WESTSIDE SUBWAY EXTENSION PROJECT

Response to Preliminary Review Comments of Century City Area Fault Investigation Report by Shannon & Wilson

Westside Subway Extension Project

April 17, 2012

Figure A-2: Historic Aerial Photo Century City Area

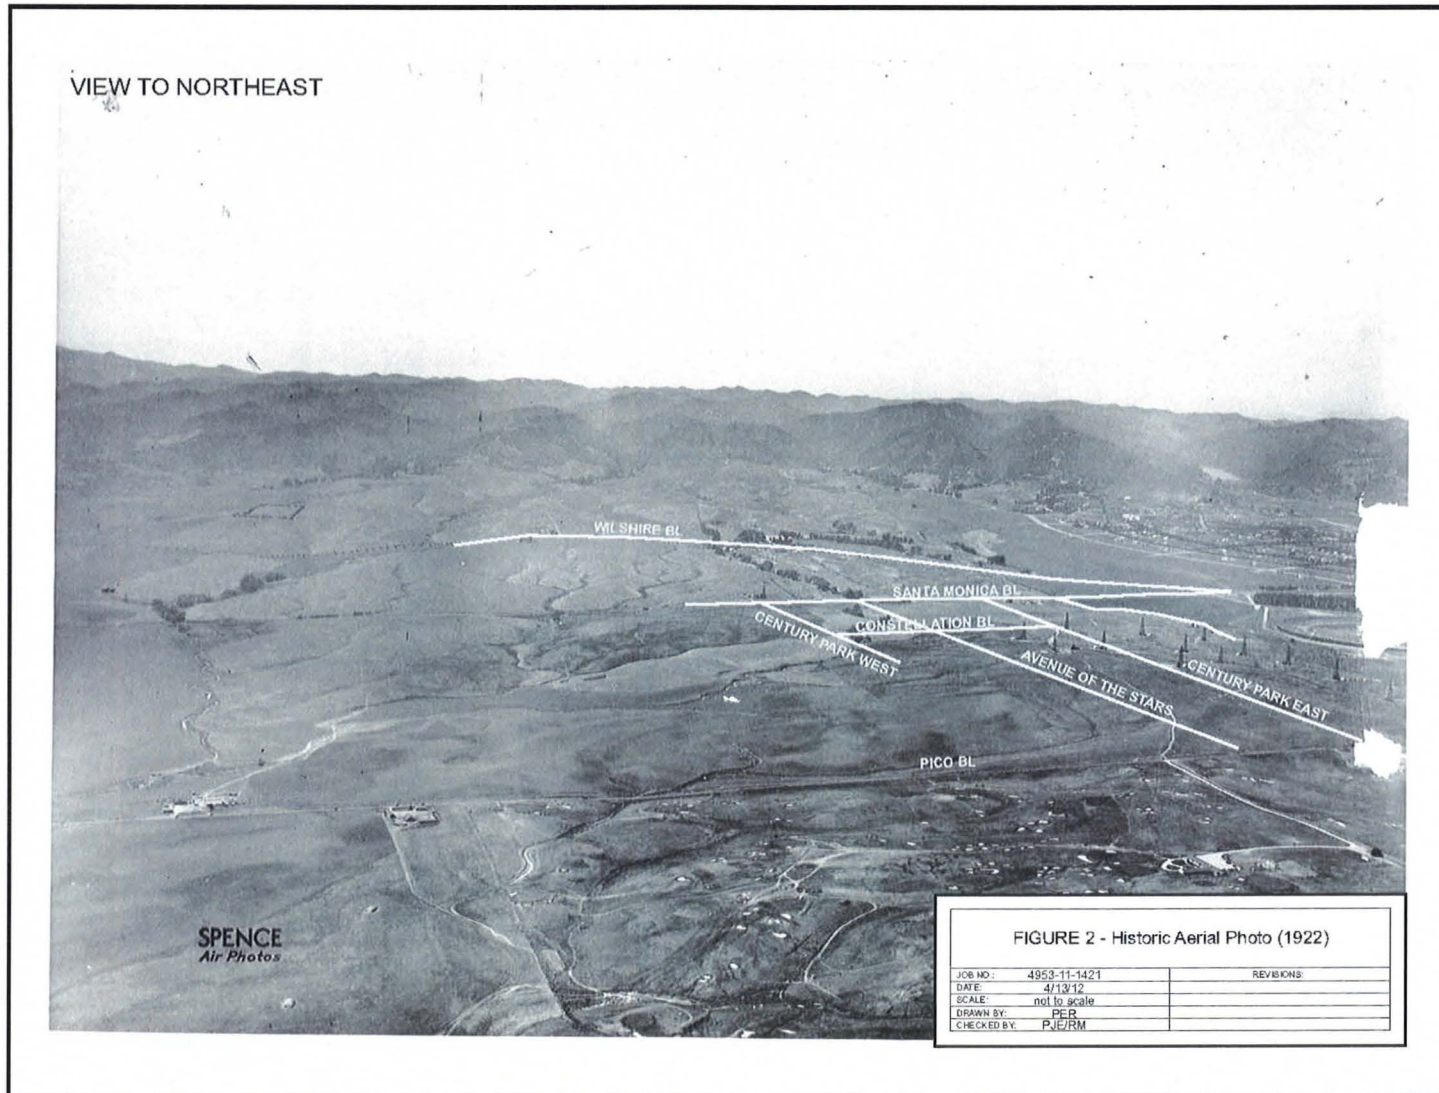
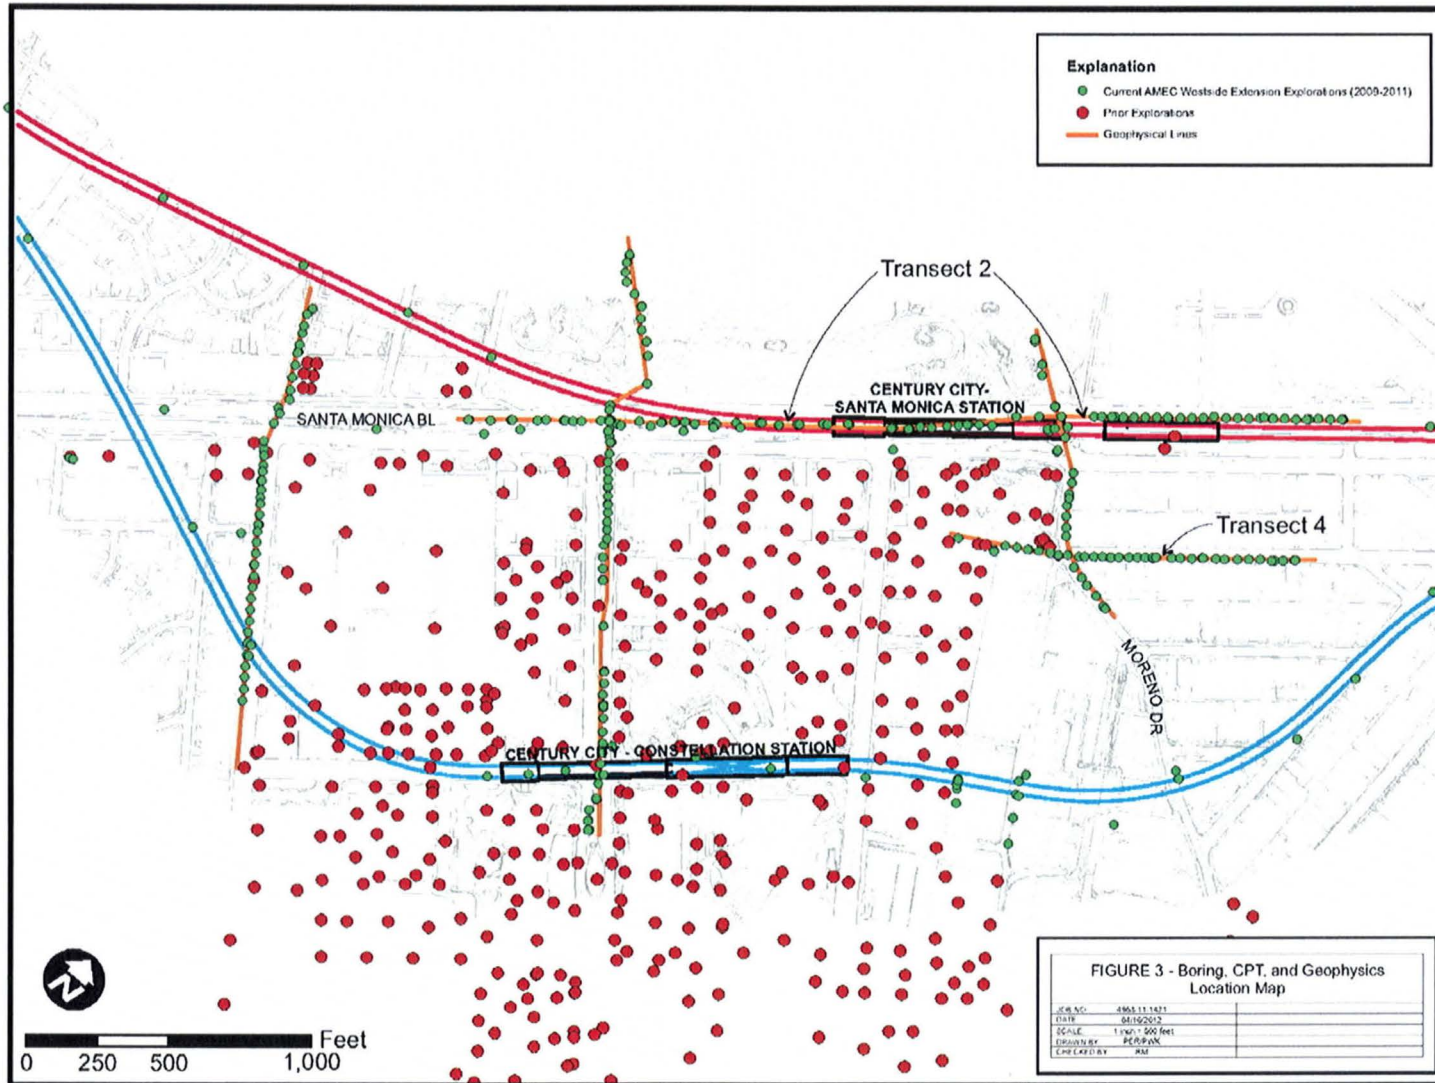
Geologic maps dating back to the early 1900s—such as Hoots (1930)—do not show faults in the Constellation Station area. Historic aerial photographs and topographic maps—including topographic maps and photos dating back to the 1910s and 1920s such as the 1922 photograph in Figure A-2 from the Spence Collection at UCLA (Spence, 1922)—show no geomorphic evidence of faulting.

Figure A-3: Past and Current Boring Locations, Century City Area

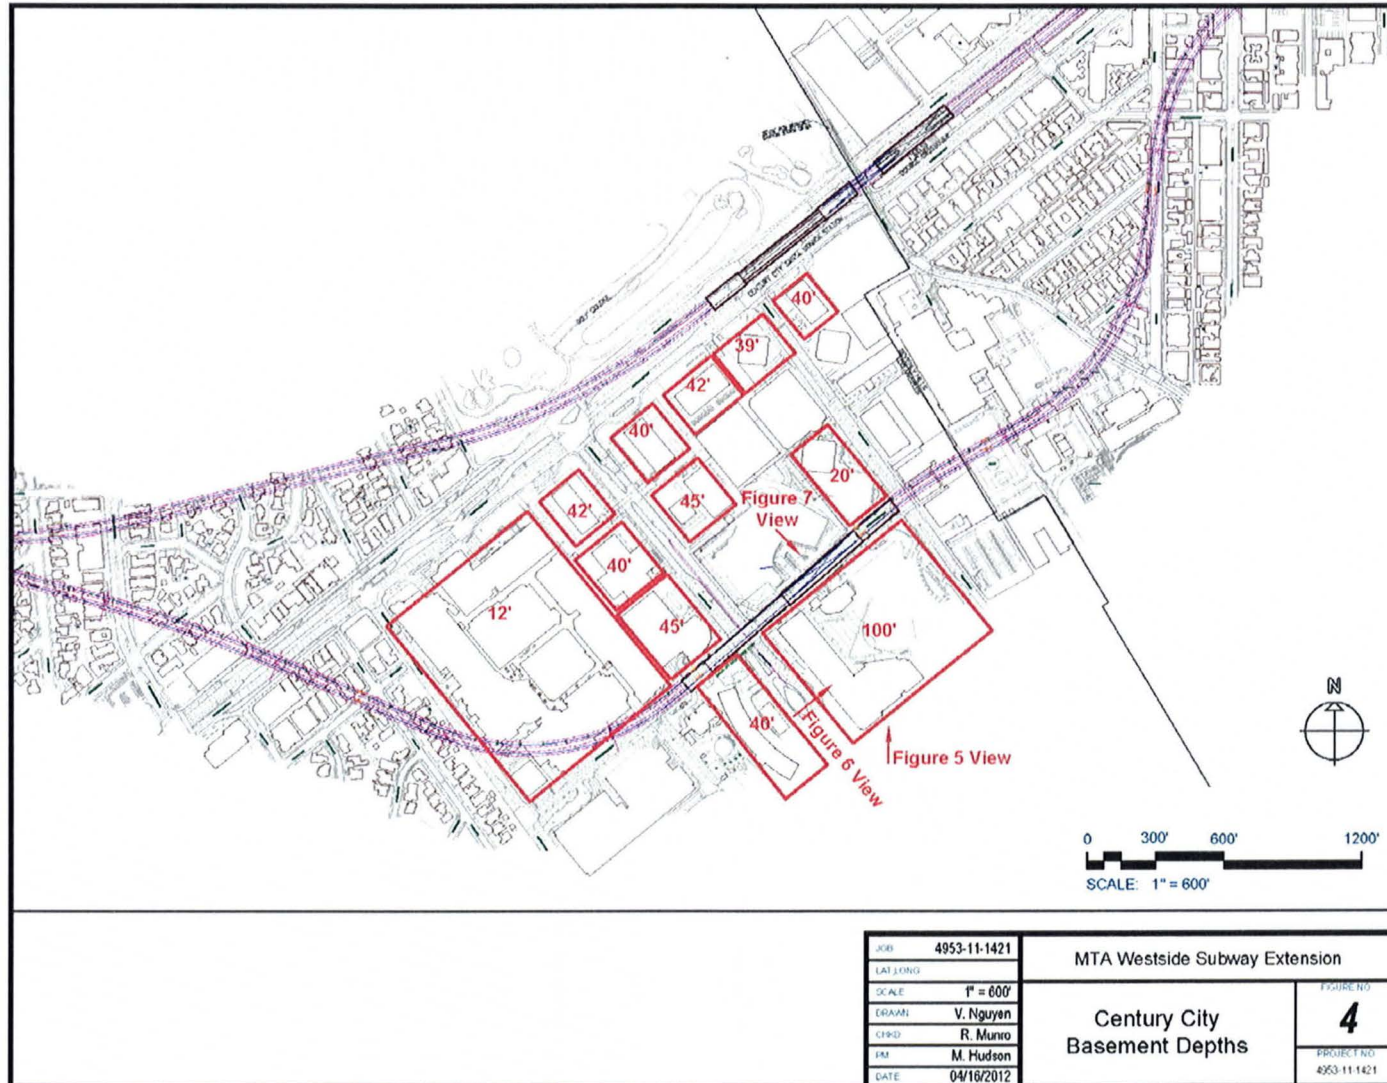
New borings, cone penetration tests (CPTs), and observation wells were excavated in Constellation Boulevard along the station alignment, and new borings, CPTs, and a seismic reflection line (crossing perpendicular to Constellation Boulevard along Avenue of the Stars) were performed during Metro's recent Westside investigation. These are also shown on Figure A-3

Shannon & Wilson Statement	Metro Response
1	<p>“studies for this [Constellation] station are not as thorough as for the Santa Monica Station.” <i>(Executive Summary pg 1)</i></p>	<p>Agree: Metro expended significant effort along Santa Monica Boulevard to find a suitable location for a station. Fewer borings were drilled at Constellation Boulevard because there was no fault identified at this site on geologic maps. However, borings from extensive prior subsurface investigations, as well as other data (maps, photos, etc) were used to support Metro’s findings at the Constellation Station site.</p>
2	<p>“we recommend that comparable geological and geotechnical explorations be carried out for the Constellation Station.” <i>(Executive Summary pg 1)</i></p>	<p>Disagree: Abundant existing information is available in the vicinity of Constellation Station (Figure A-3) from previous investigations. These other studies show no evidence of faulting at the site.</p>

Figure A-5: Construction of Deep Excavation, Century City Looking North

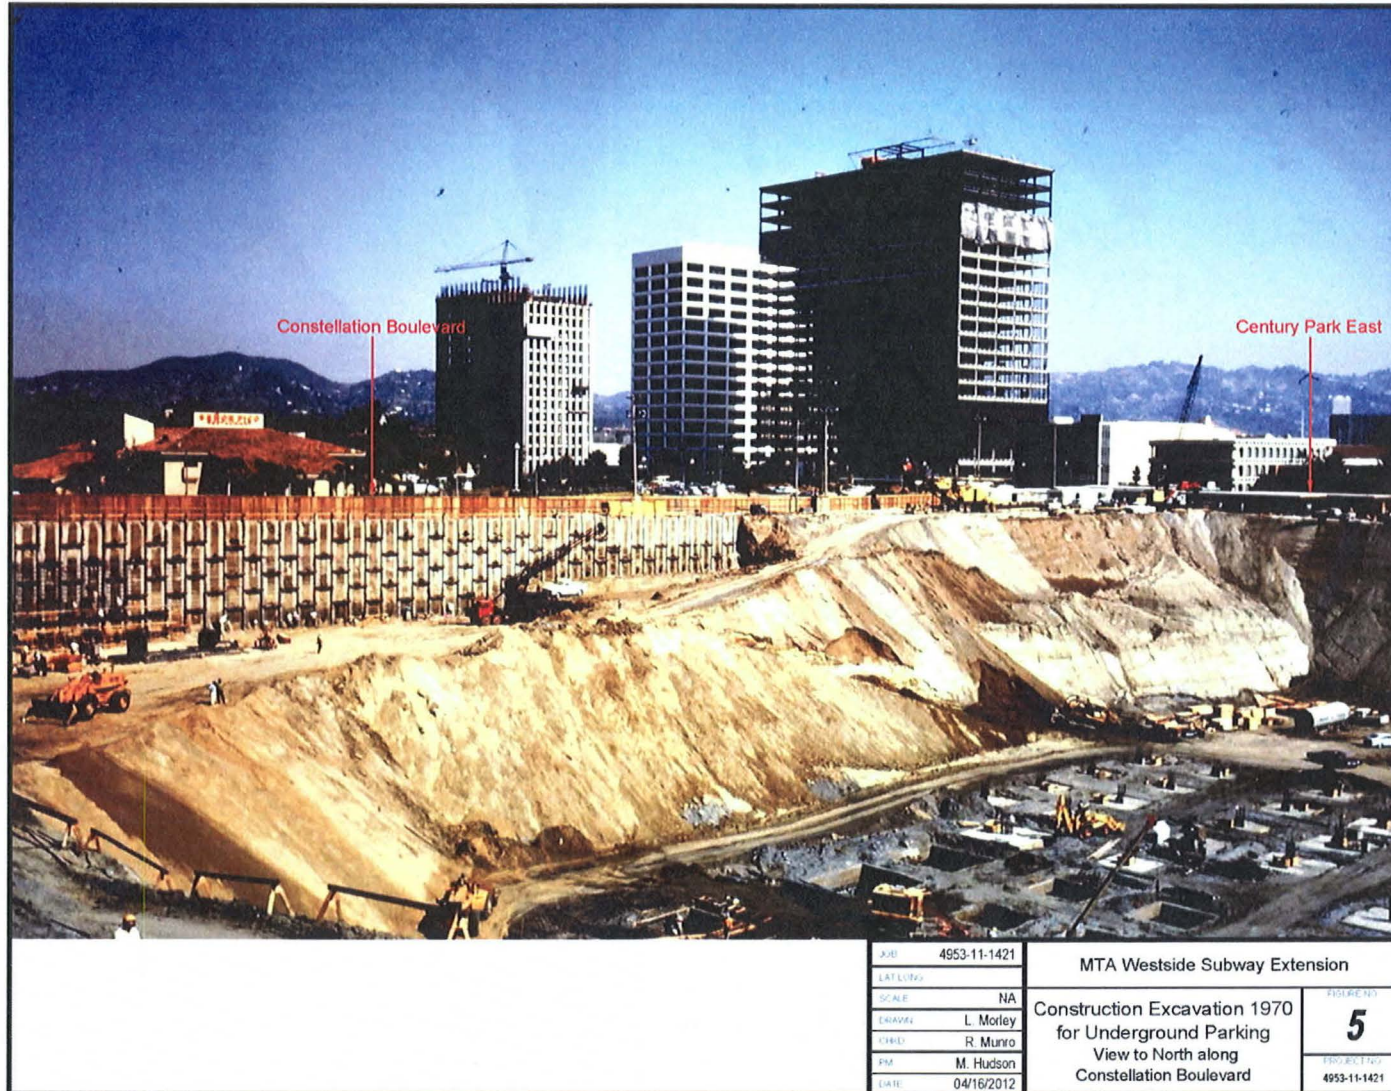
Metro reviewed data from previous geotechnical investigations and construction observations included boring logs from the investigations and photographs taken during excavations for deep underground parking garages. Figure A-3 shows the locations of the extensive geotechnical explorations conducted in the Constellation Station area dating back to 1959. In addition to the borings drilled for the foundation investigations, geotechnical observations were performed during construction, and the excavations were documented in photographs. Most of the buildings in the area have underground parking garages (Figure A-4). Figure A-4 also shows the locations of the construction excavation photographs in Figure A-5, 6, and 7. These photos show the 80- to 100-foot-deep underground parking excavation for the building adjacent to Constellation Boulevard to the south. Figure A-5, looking northwest along Constellation Boulevard, shows what will be the southern wall of the Constellation Station excavation. Based on the construction photos taken periodically during the excavation process (Figure A-5, Figure A-6 and Figure A-7), offsets of horizontally bedded sediments are not observed across the excavation.

Figure A-9: Transect 4, Century City Fault Investigation

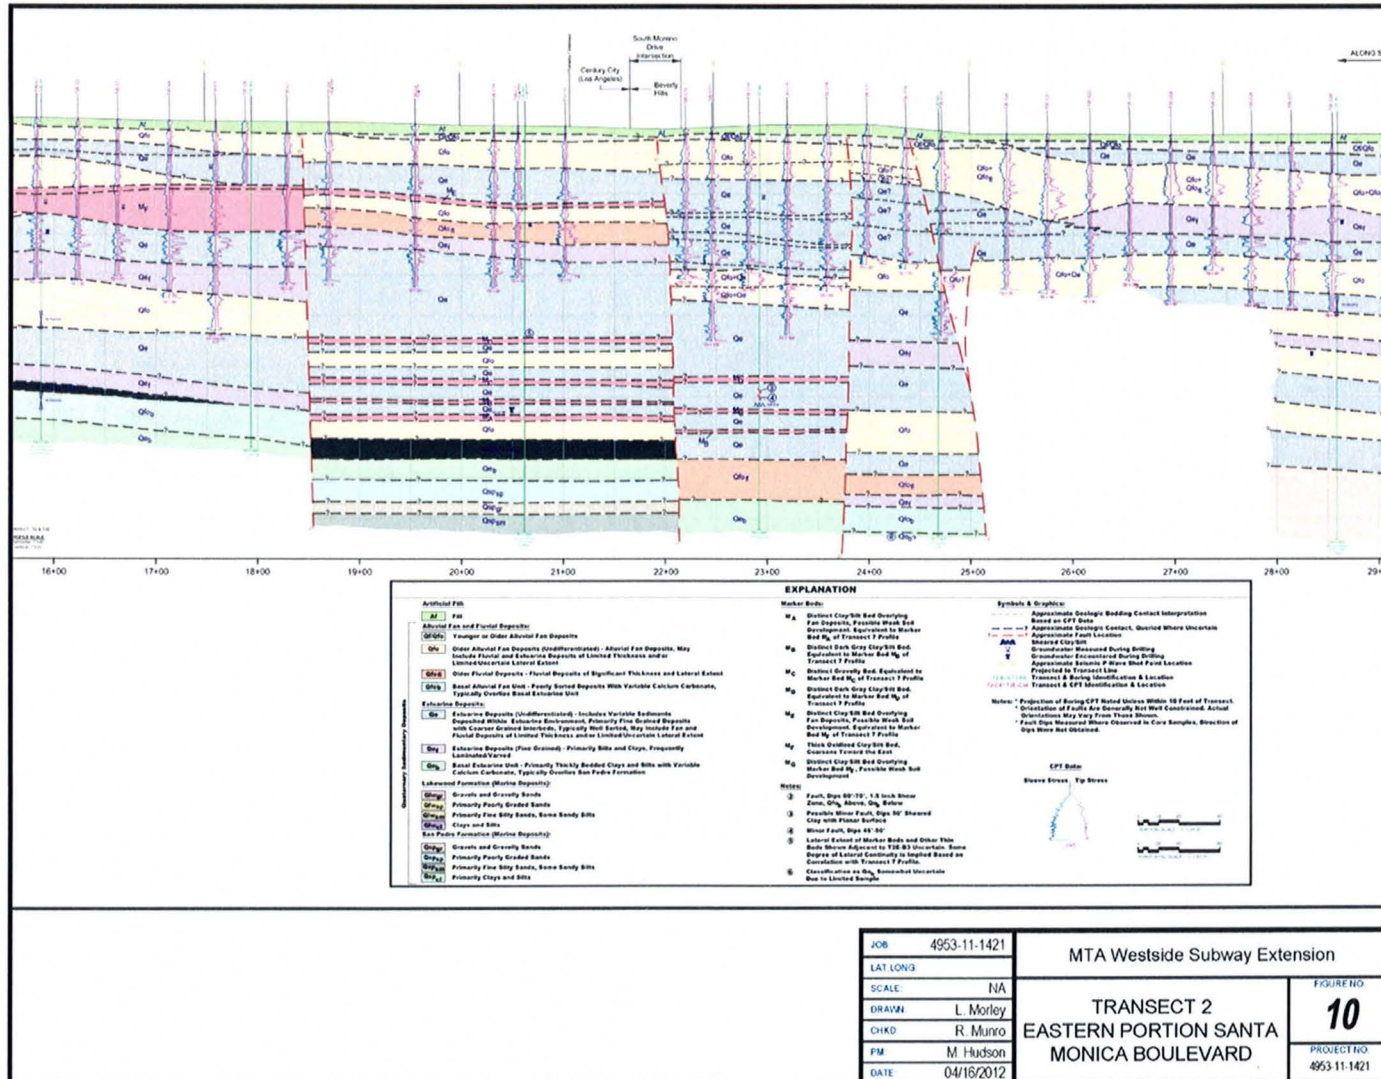
The data from that investigation—described, in part, by the letter report by Roy J. Shlemon and Associates, Inc. (Appendix B)—are not available to Metro so comment cannot be made on them. However, the results of that investigation would not preclude the presence of faults of the WBHL in Santa Monica Boulevard. Based on the closely spaced borings and CPTs, the seismic reflection data, and the review of historical topographic maps and aerial photographs performed in Metro's investigation, there are unquestionably faults present in Santa Monica Boulevard. These faults are clearly seen in the geophysical survey line Transect 4 shown on Figure A-9. The difficulty is determining the level of activity of the faulting.

Figure A-10: Transect 2, Century City Fault Investigation

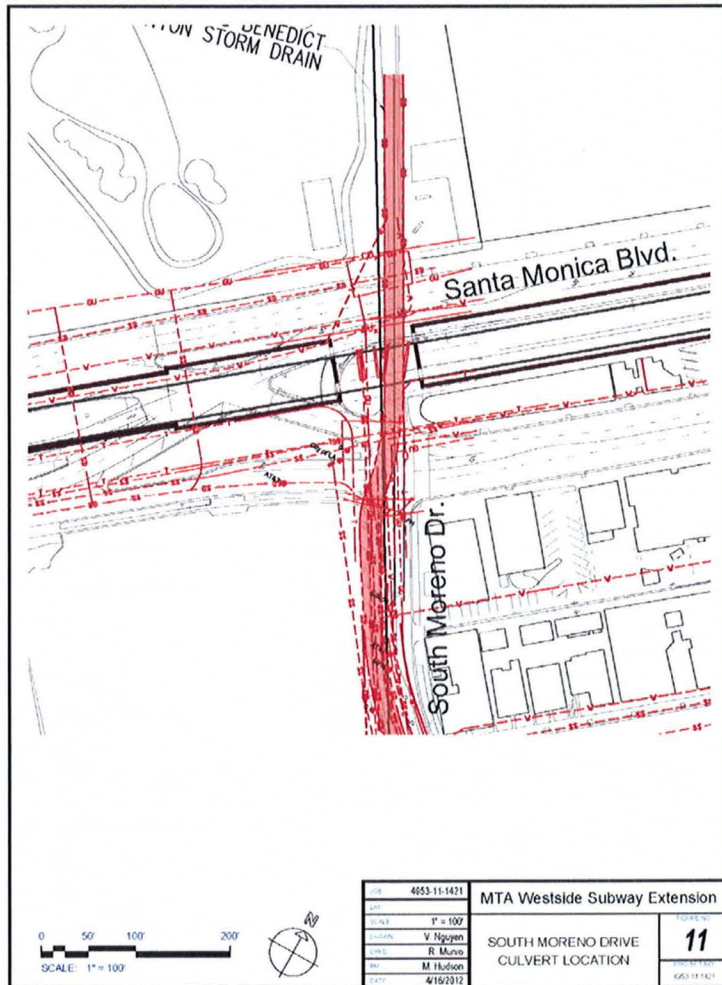
property) would not address the area at the intersection of Santa Monica Boulevard and South Moreno Drive, where significant fault offset was observed in the borings, CPTs, and geophysical survey line (second fault from the left on Figure A-10). In addition to the 10 (or more) north-south trending utility lines in the intersection, there is a 20-foot-wide box culvert more than 24 feet deep in South Moreno Drive at the intersection (Figure A-11). Excavation of trenches to emplace these subsurface utilities has destroyed the original layering necessary to identify faults (or the lack thereof), and there is no possibility that undisturbed Holocene sediments that could be used to evaluate the activity of that faulting remain in the intersection.

Figure A-13: Subway Station East of Moreno Drive

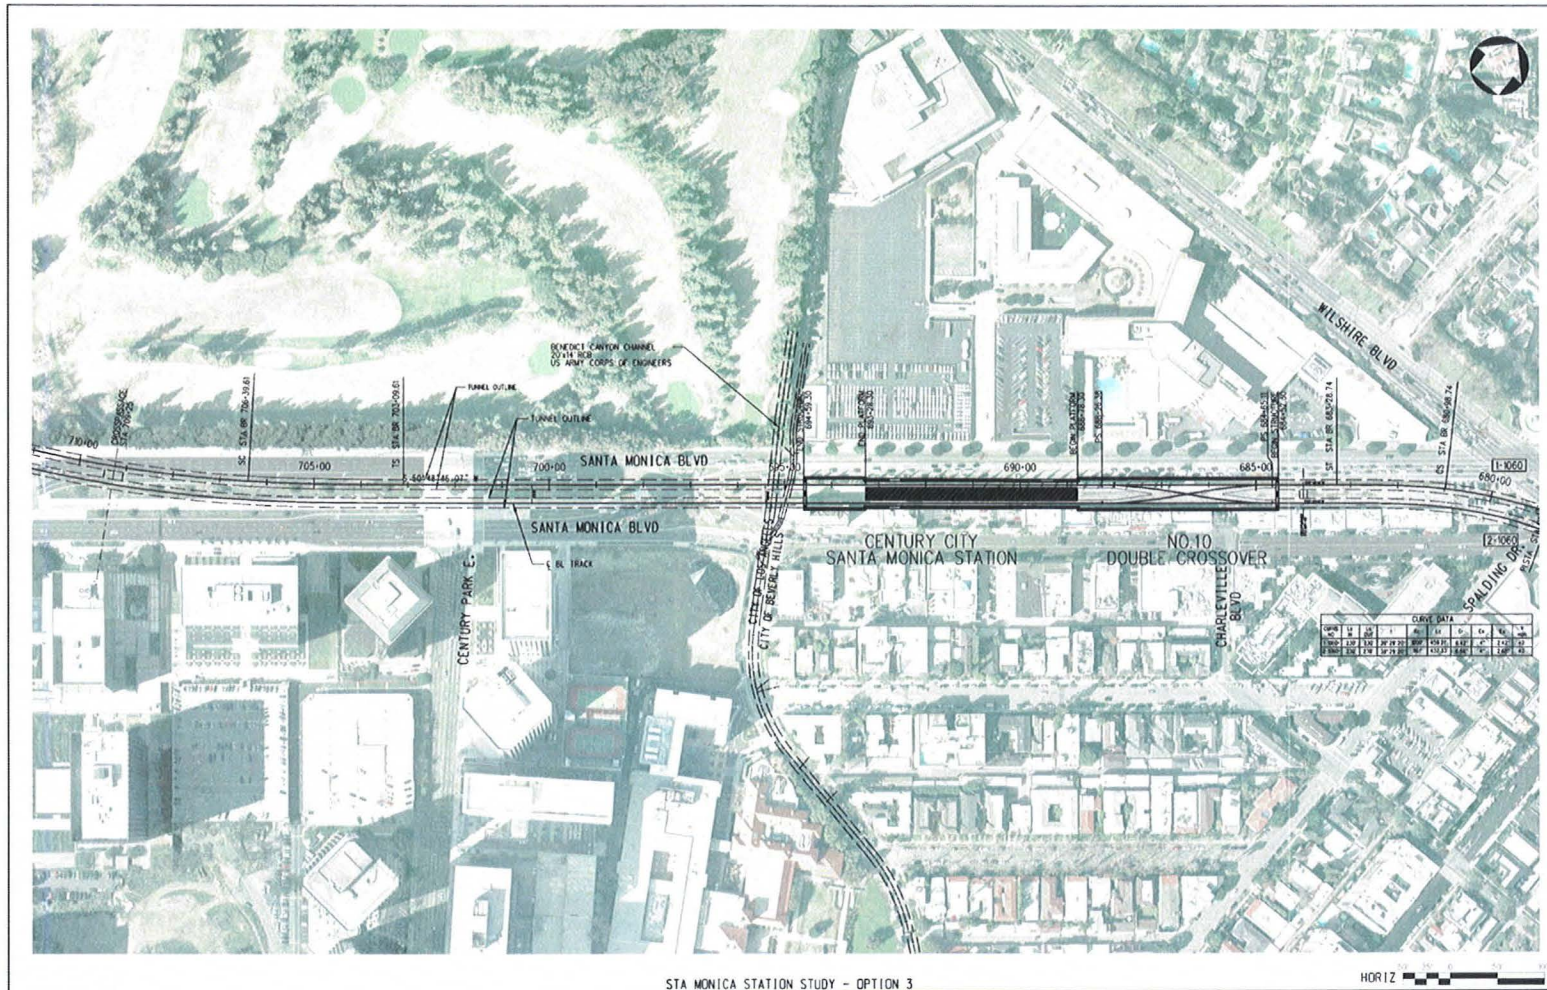
The first alternative, moving the underground station to the east, is shown in Figure A-13. The station has been moved northeast to just clear the Benedict Canyon box culvert in an attempt to clear the fault zone (refer to Figure A-14 for the station against the fault zone locations), but portions of the station platform would remain in the fault zone. There is just enough room at that location to fit the station box and crossover and still have room for a reasonable curve onto Wilshire Blvd. The west end of the station structure does not clear the fault zone, but this is as far east as the station box can practically be moved. Aside from being in the fault zone, this does not appear to be a practical solution from a planning perspective because it moves the station entrance farther away from the major pedestrian activity center. The entrance is now more than 700 feet from Century Park East.
